2. Name of Operator **Ridgeway Arizona Oil Corp.**

8. Well Name and No. **Farrell Federal # 2**

Proposed Plug & Abandonment Procedure

**Farrell Federal 2
30-041-10212
Ridgeway Arizona Oil Corp
September 5, 2019
Conditions of Approval**

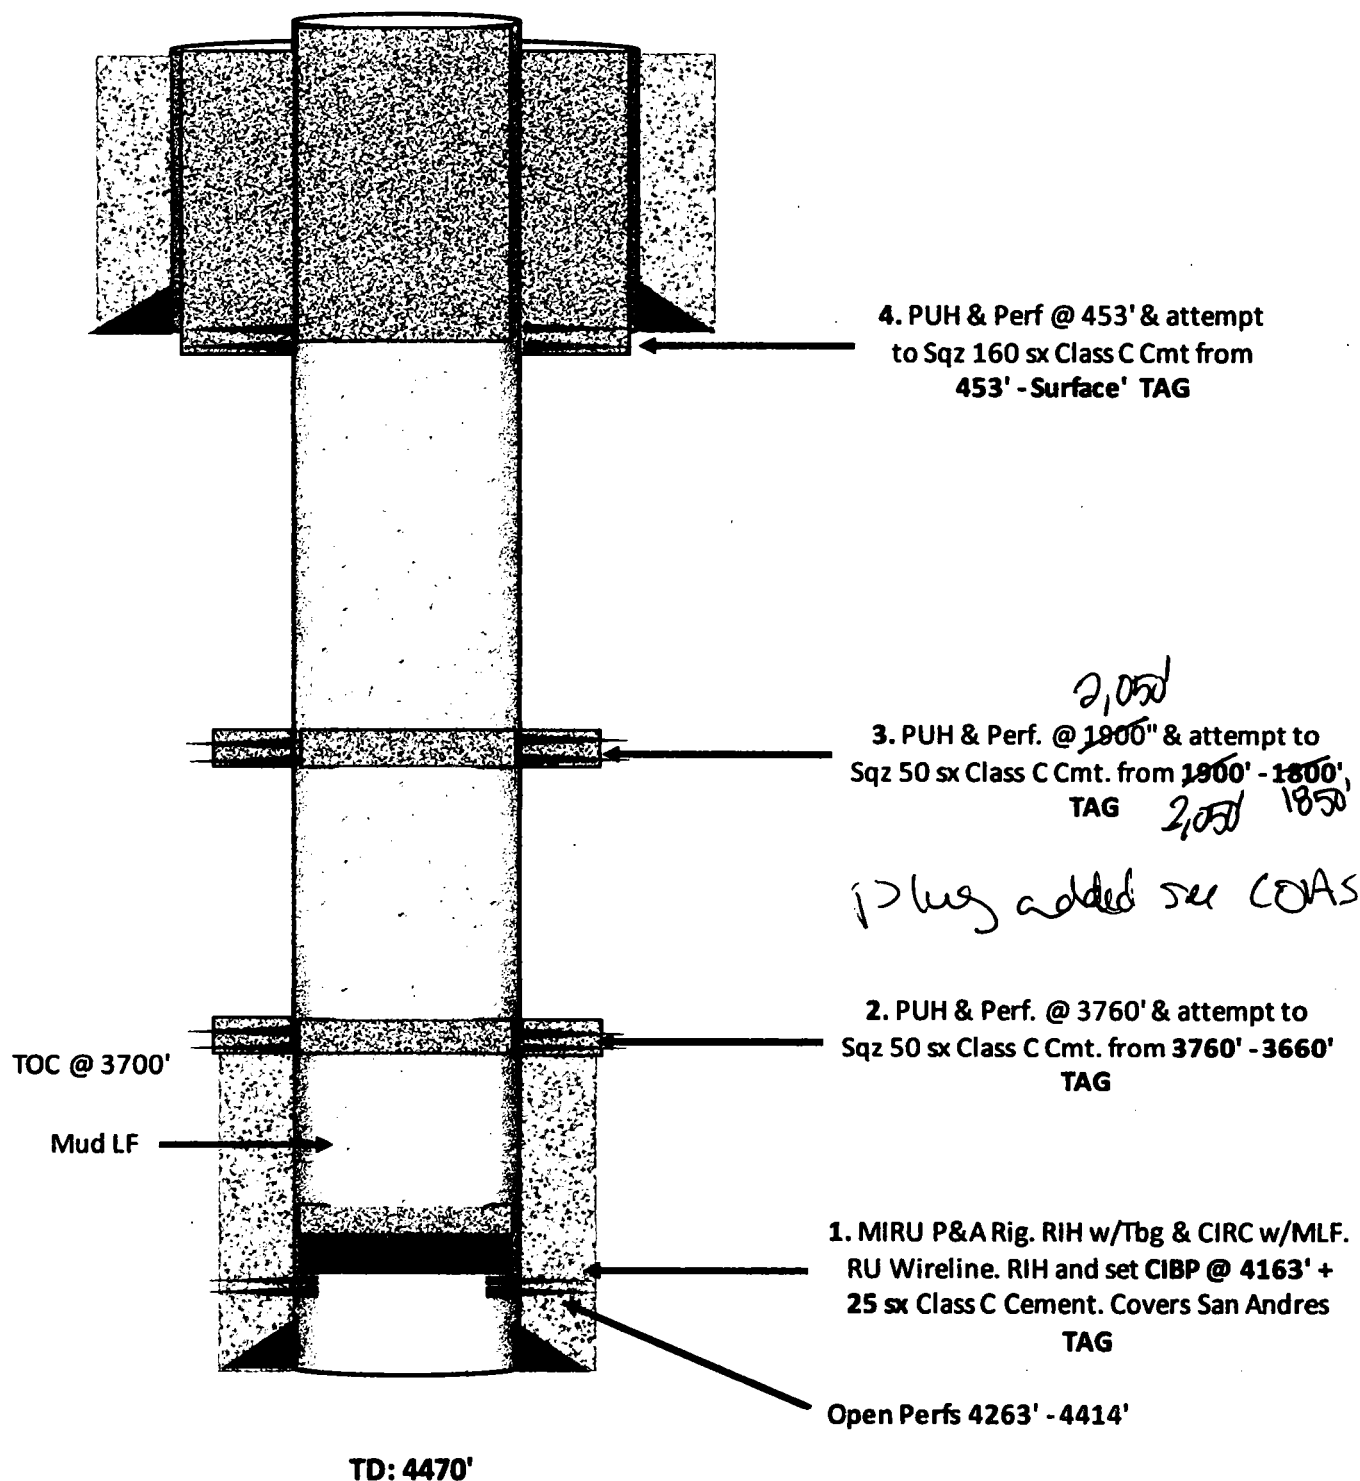
1. Operator shall place CIBP at 4,163' (50'-100' above top most perf) and place 25 sx of Class C cement on top as proposed. WOC and TAG.
2. Operator shall perf and squeeze at 3,760' as proposed. Operator shall place a balanced Class C cement plug from 3,760'-3,660' as proposed. WOC and TAG.
3. Operator shall perf and squeeze at 2,350'. Operator shall place a balanced Class C cement plug from 2,350'-2,225' to seal the Yates Formation and the bottom of the Salt. WOC and TAG.
4. Operator shall perf and squeeze 50 sx of class C cement as proposed at 2,050'. Operator shall place a balanced Class C cement plug from 2,050'-1,850' to seal the top of the Salt. WOC and TAG as proposed.
5. Operator shall perf and squeeze at 453' as proposed. Operator shall place a balanced Class C cement plug from 453' to surface to seal the 8-5/8" casing shoe.
6. See Attached for general plugging stipulations.
